STAFF REPORT
COMMUNITY DEVELOPMENT DEPARTMENT

SUBJECT: FP-2022-0006
Oakwind Estates No. 2

LOCATION: The site is located at 6180 W. McMillan Rd, in the SW ¼ of the SW ¼ of Section 28, Township 4N. Range 1W.

B. Final Plat (date: 2/3/2022)

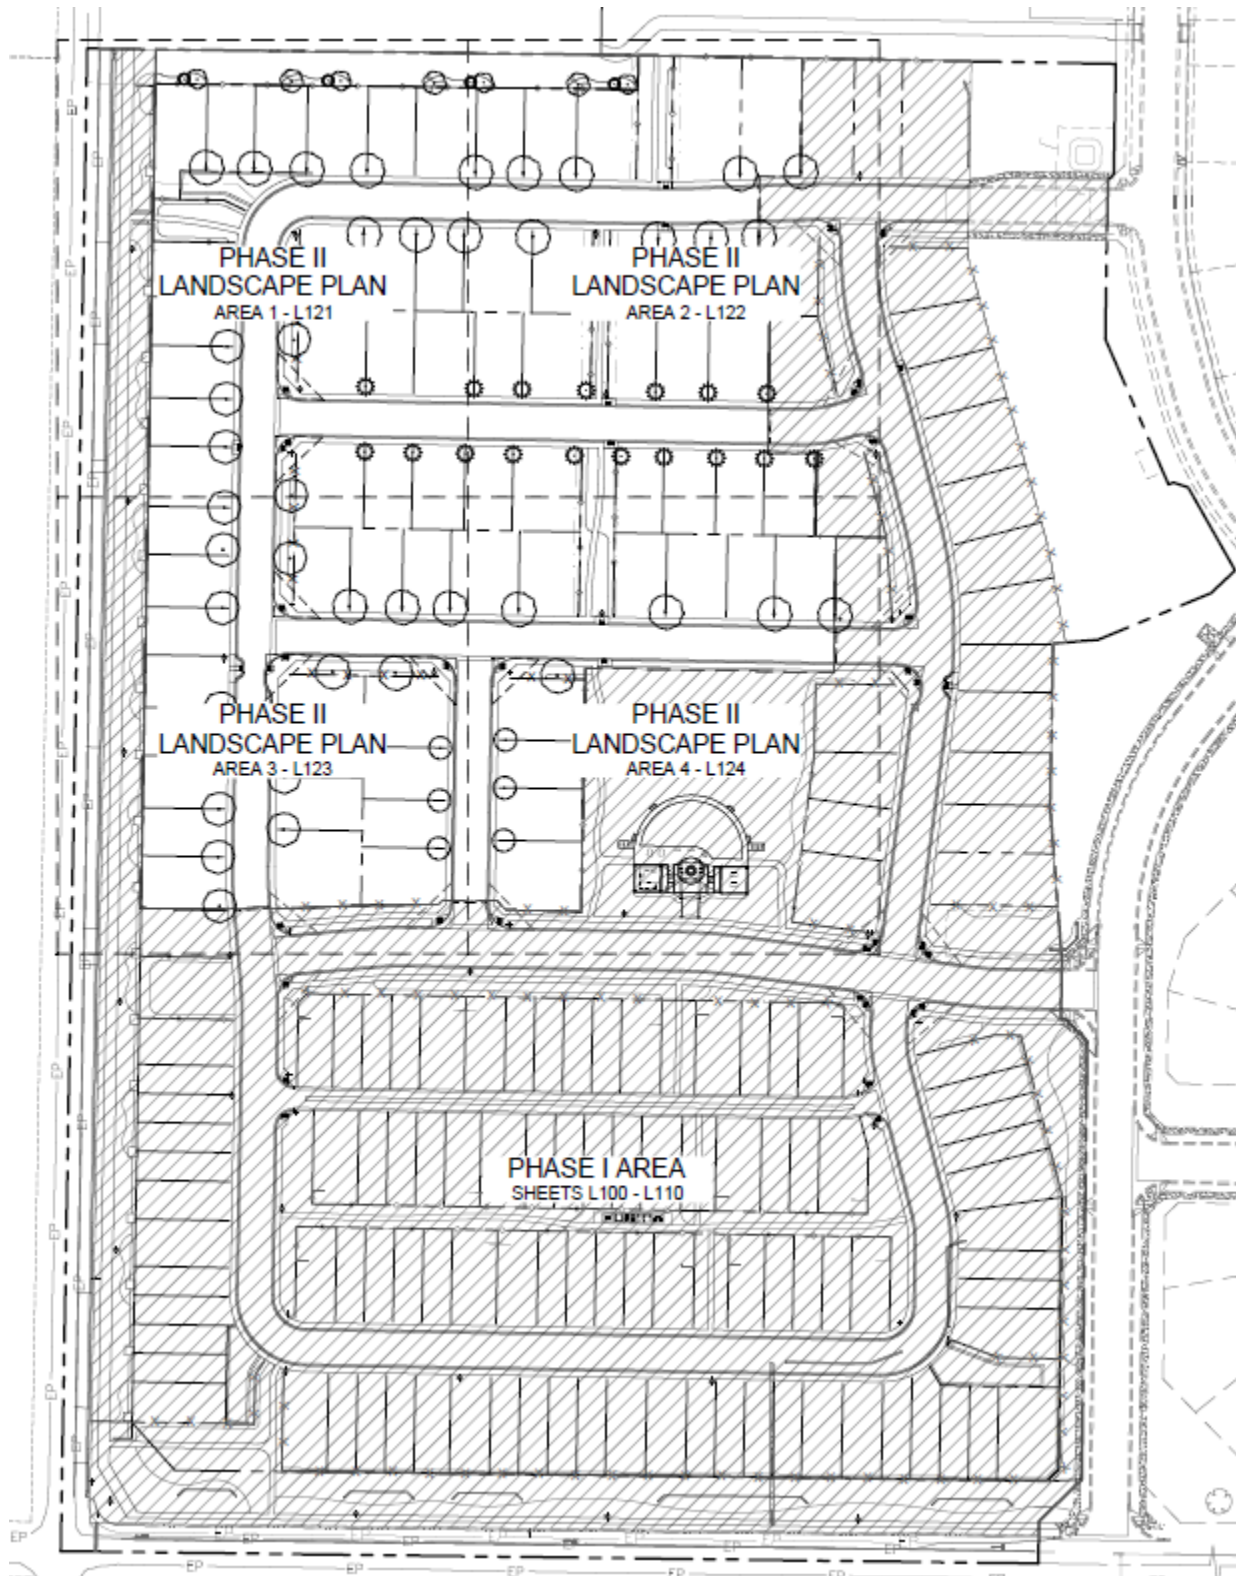
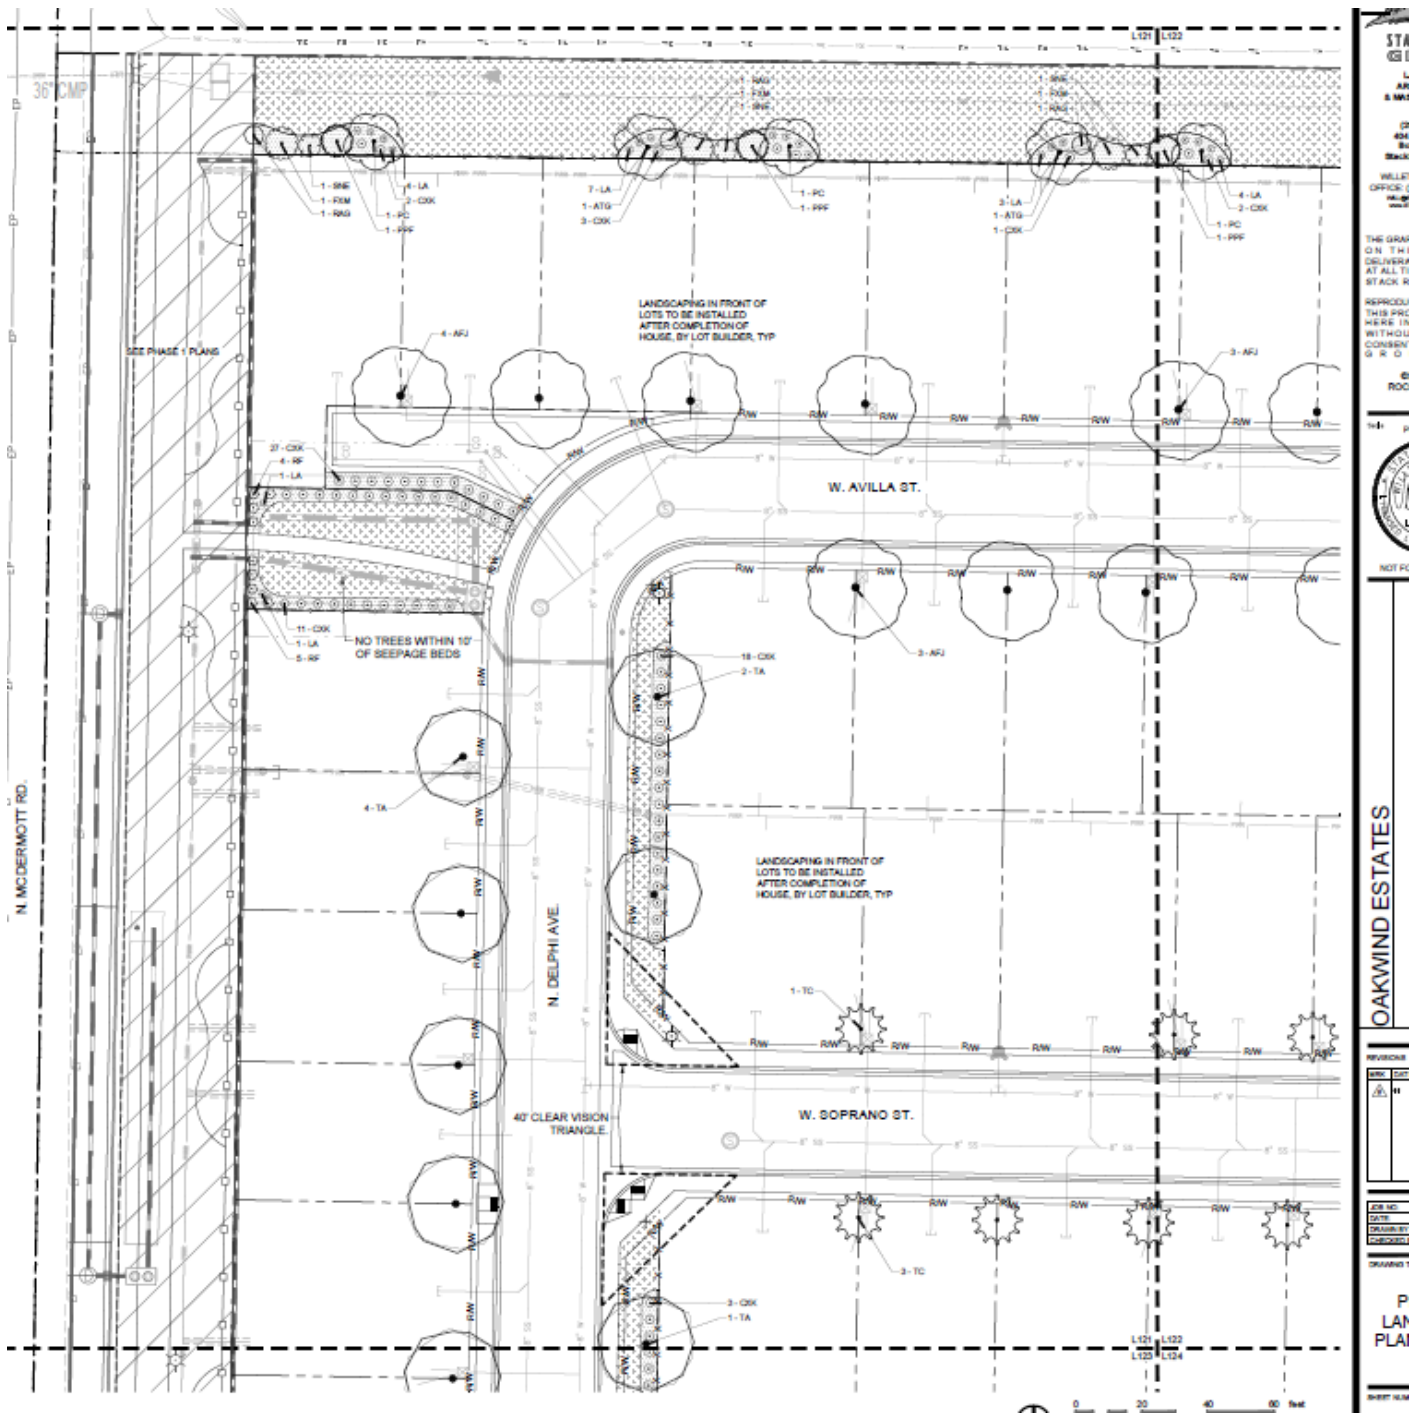
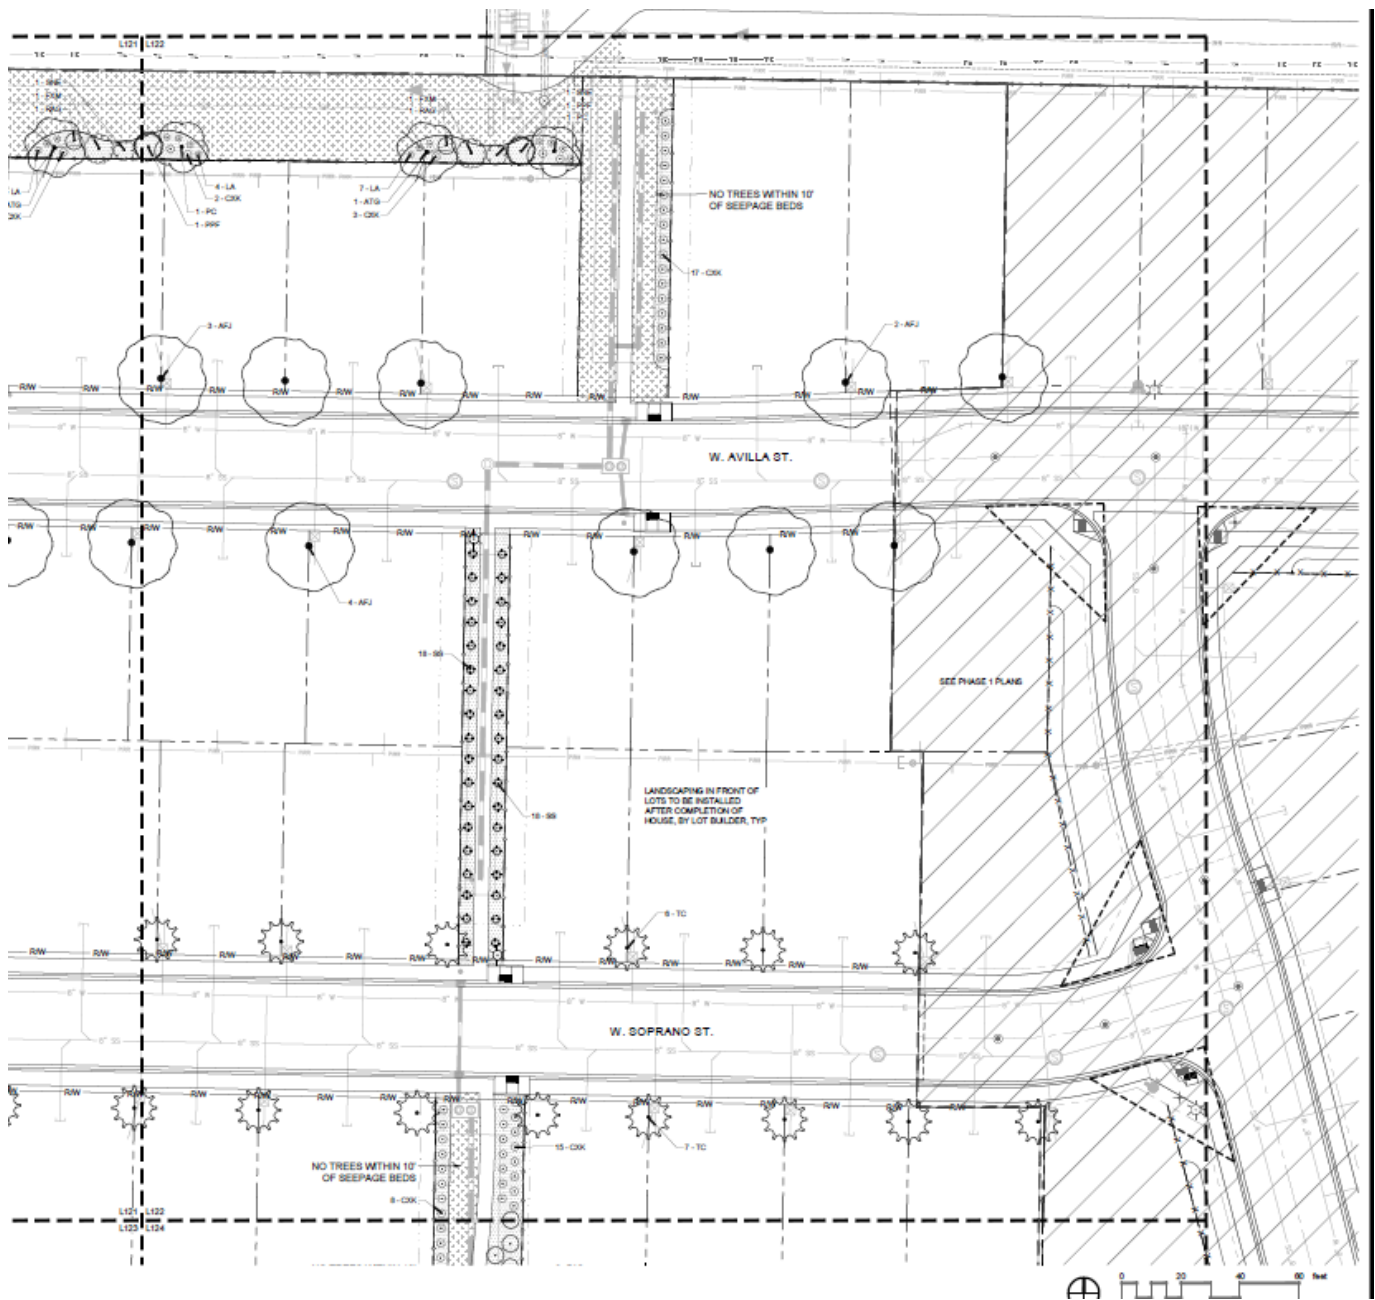
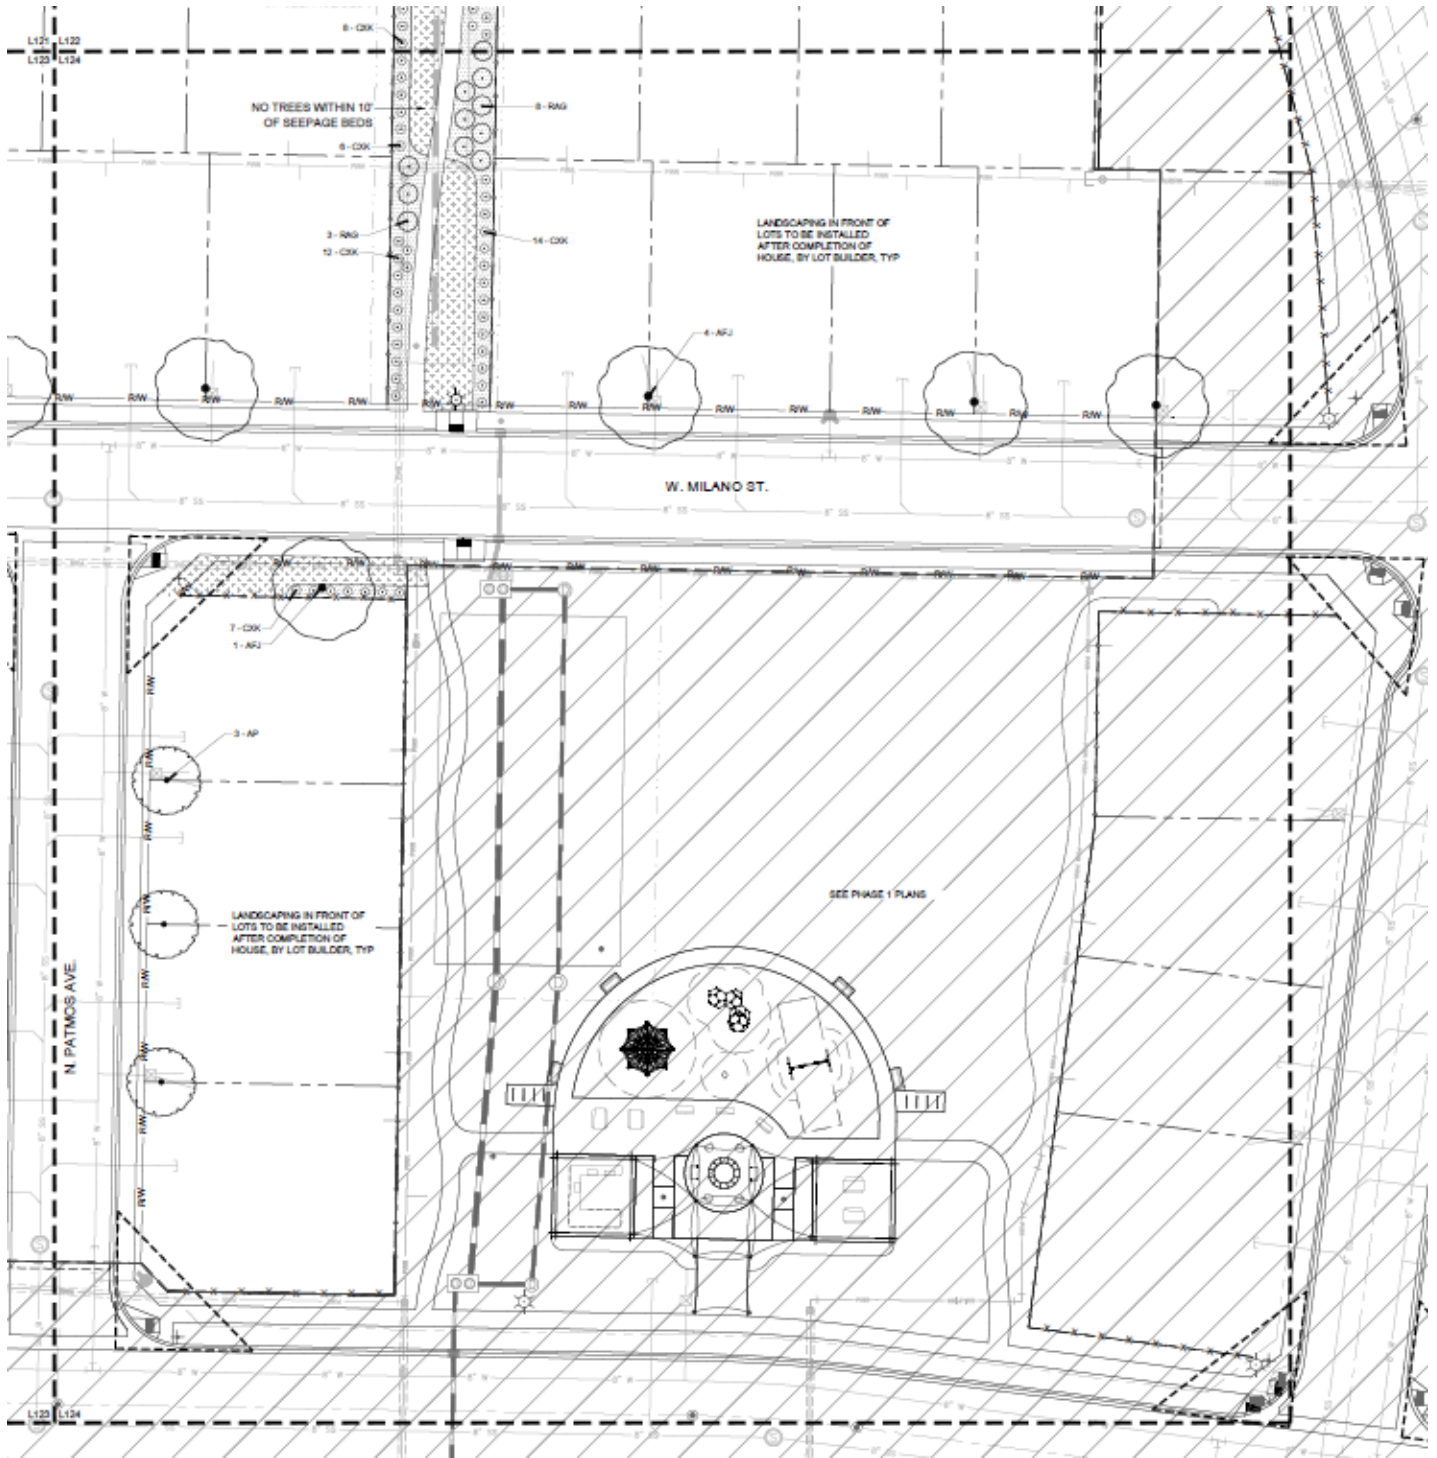
- a. Note 10, add Instrument Number.
 - b. Note 12, add Instrument Number.
4. The landscape plan, prepared by Stack Rock Group on 02/04/2022 is approved with the following revisions:

C. Landscape Plan (date: 02/4/2022)

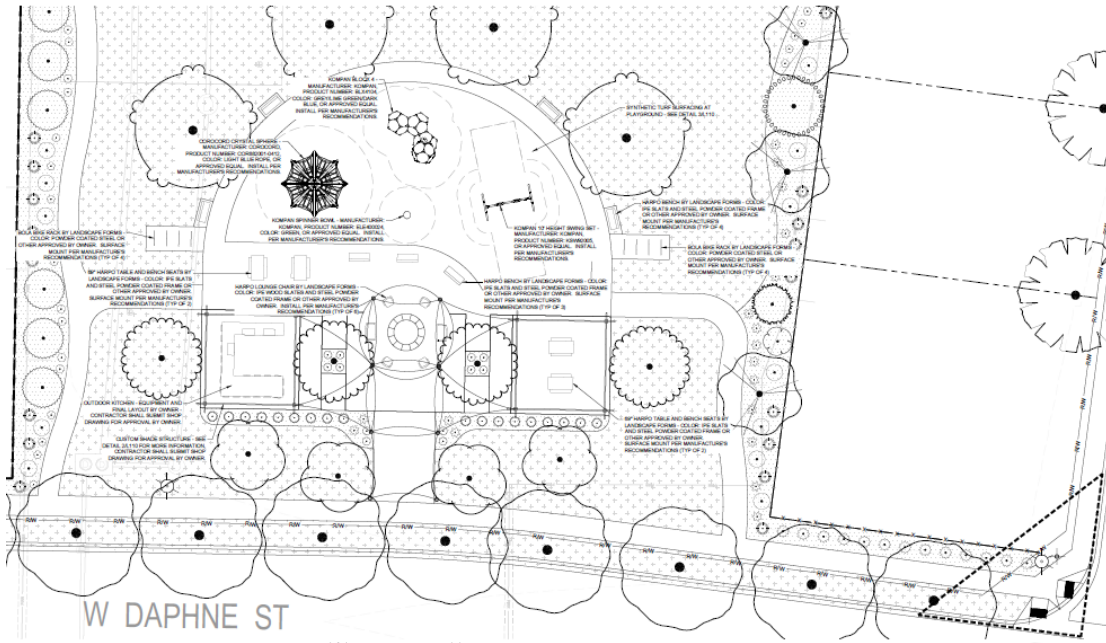
UDC 11-3B-12 requires all pathways to be landscaped with a strip a minimum of five (5) feet wide along each side of the pathway, with a mix of trees, shrubs, lawn, and/or other vegetative ground cover and a minimum of one (1) tree per one hundred (100) linear feet of pathway. There are pathway lots in which this requirement is not met. This includes Lot 8 Block 6, Lot 7 Block 7, and Lots 6 and

18 Block 8. The applicant will either need to revise the landscape plan to meet the regulations, or apply for alternative compliance prior to signature on the final plat.

- a. All pathway lots (Lot 8 Block 6, Lot 7 Block 7, Lot 6 and 18 Block 8) shall be planted in accordance with UDC 11-3B-12 including a landscape strip a minimum of five (5) feet wide along each side of the pathway and one (1) tree per one hundred (100) linear feet of pathway, or the applicant shall apply for alternative compliance prior to signature of the City Engineer on the final plat.
